Subject: Preliminary Draft Responses to NRC Request for Information  
- Pool Bypass

Reference: FAX to Duncan from Palla, 8/18/92, "Request for Additional Information Regarding Analysis of LOCAs Outside Containment (0-4)"

FIGURE 1  
LOCA OUTSIDE CONTAINMENT

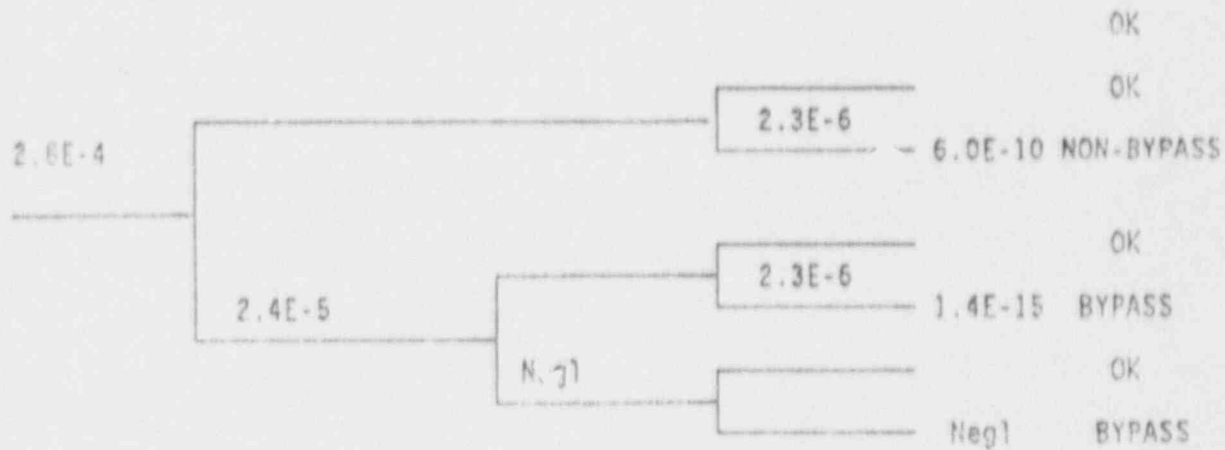
Concern 1. Please provide a more comprehensive analysis of the frequency of core damage from LOCAs outside containment using event tree and fault tree techniques. The analysis is to include the effects of instrumentation availability and consequential failure of injection systems.

RESPONSE This concern addresses the assumption in the analysis that the value of  $Q_1$  in the event trees. It is apparent from Figure 1 that these events can not be significant unless the amount of increase in the coolant makeup frequency ( $Q_0$ ) is greater than the probability that the coolant makeup frequency is affected ( $Q_1$ ).

RESPONSE Simplified event trees of the containment bypass events are shown in Figures 1 and 2. Figure 1 represents the LOCA outside containment events. Figure 2 represents containment bypass situations which occur independently from the initiating event. For both trees the end result is either equivalent full bypass or no bypass. Probabilistic values shown are derived from Table 19E.2-21 of the SAR.

$V_1$  The frequency of piping breaks in lines which communicate directly with the reactor vessel. The value used ( $2.6E-4$ ) is the total estimated frequency for small, medium or large breaks outside of containment. The basis for this estimate is provided in Appendix 19E.2.3.3.3 (2)(k).

$Q_1$  Conditional probability that required makeup for core cooling is affected by the ex-containment LOCA. It is assumed that such failure results from environmental effects (including flooding). The value  $Q_1$  is discussed in response to concern 3. When isolation is successful core cooling is assumed to be unaffected by the brief period of break flow and a value of 1.0 is assumed.

Conditional probability of core cooling failure by all sources of cooling not affected by the ex-containment LOCA. The values used are derived from the event trees in Appendix 19D.4. When used with  $V_0$ , the product ( $Q_0 * V_0$ ) is the total core damage frequency calculated in the current PRA ( $1.5E-7$ ).

Bypass Fraction - Total conditional probabilities of all ex-containment LOCA paths (from Table 19E.2-21). Conditional probabilities are weighted by a "flow split fraction" to account for different consequences from individual lines. The result is therefore the equivalent full bypass fraction.

As shown on Table 19E.2-21 and Figure 1, the bypass fraction from ex-containment LOCAs is equal to  $2.4E-5$ .

Although the consequence from bypass events is greater, the frequency of such events concurrent with core damage is extremely small ( $2.3E-12/\text{yr}$ ). This is well below the criteria of exclusion for consideration in the PRA, regardless of consequence.
